SUBJECT: NORTH ANNA POWER STATION, UNIT 2 - AMERICAN SOCIETY OF  
MECHANICAL ENGINEERS BOILER AND PRESSURE VESSEL CODE,  
SECTION XI RELIEF REQUEST CMP-020 (TAC NO. MB7515)

SAFETY EVALUATION BY THE OFFICE OF NUCLEAR REACTOR REGULATION

RELIEF REQUEST CMP-020

NORTH ANNA POWER STATION, UNIT 2

Cross-sectional view of head-to-flange Weld 1 showing the required inspection volume (within dashed lines), weld and UT beam. The figure illustrates that inspection from the flange side is severely limited due to transition angle and location of weld.

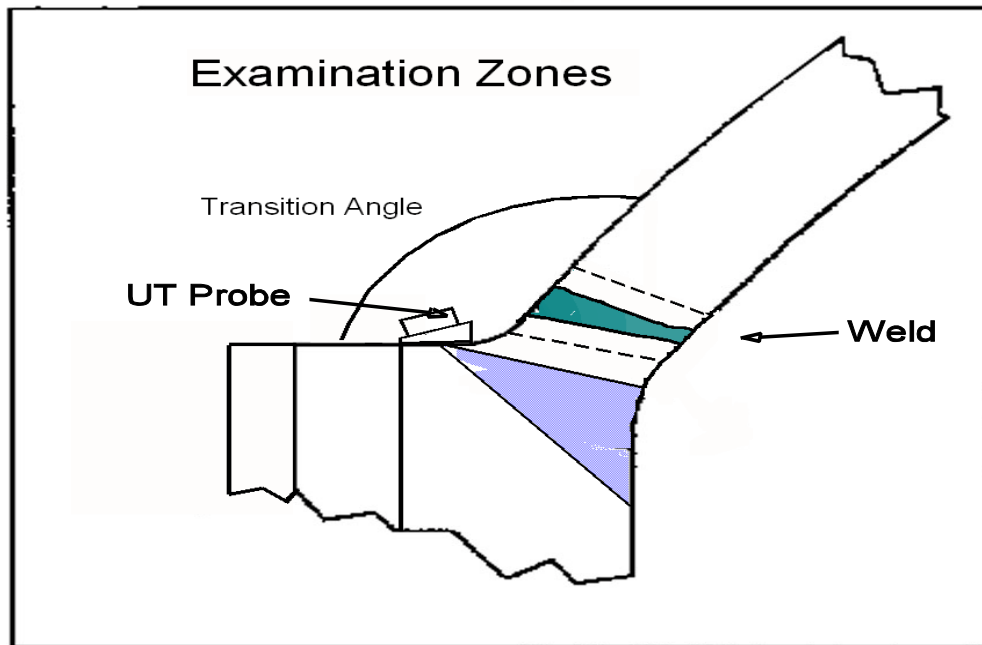
The examination volume for the Reactor Head-to-Flange Weld is defined in Figure IWB-2500-5. The examination volume can be scanned along the weld axis from two directions. However, due to the extreme angle of the transition from the curvature of the

head base material to the flange (See figure 1 below)<sup>1</sup>, access for scanning perpendicular to the weld axis is restricted to only the head side of the weld.

Scanning from the flange side of the weld is limited to 0.5 inches from the weld toe due to the flange configuration.

The cross-sectional geometry of the component at Weld 1 produces a high transition angle between the flange and the domed head. As illustrated in Figure 1, scanning from the flange side of the weld is severely limited due to location of the weld and the transition angle. In addition, the location of three closure head lifting lugs further restrict access for ultrasonic examination. For these reasons, the component configuration does not allow the licensee to obtain the full Code-required volumetric coverage from both sides of the weld. For the licensee to achieve 100% volumetric coverage, the RPV closure head would have to be redesigned and modified. This would place a significant burden on the licensee, thus the Code-required 100% volumetric examination is impractical for Weld 1.

As shown on the sketches and technical descriptions<sup>2</sup> provided by the licensee, a substantial amount (approximately 66%) of the Code-required examination volume can be obtained with the perpendicular, parallel and 0° ultrasonic scans performed from the head side of the weld. For both the 45° and 60° scans, the licensee was able to achieve the Code-required coverage from a single side. Apart from the Code volumetric examinations, the licensee also performs a separate 65° shear wave ultrasonic inspection from the head side of the weld to produce a sound field nearly perpendicular to the weld/base metal interface, as recommended by NRC Regulatory Guide 1.150, *Ultrasonic Testing of Reactor Vessel Welds During Preservice and Inservice Examinations*, Rev.1, February 1983. In addition to the volumetric examinations of this weld, the licensee was able to obtain essentially 100% of the Code-required surface examinations performed on the outside of the component. The examinations completed by the licensee establish a reasonable basis for comparison with future inservice examinations and should have detected any significant conditions that might challenge the structural integrity of the subject welds. Therefore, pursuant to 10 CFR 50.55a(g)(6)(i), it is recommended that relief be granted.
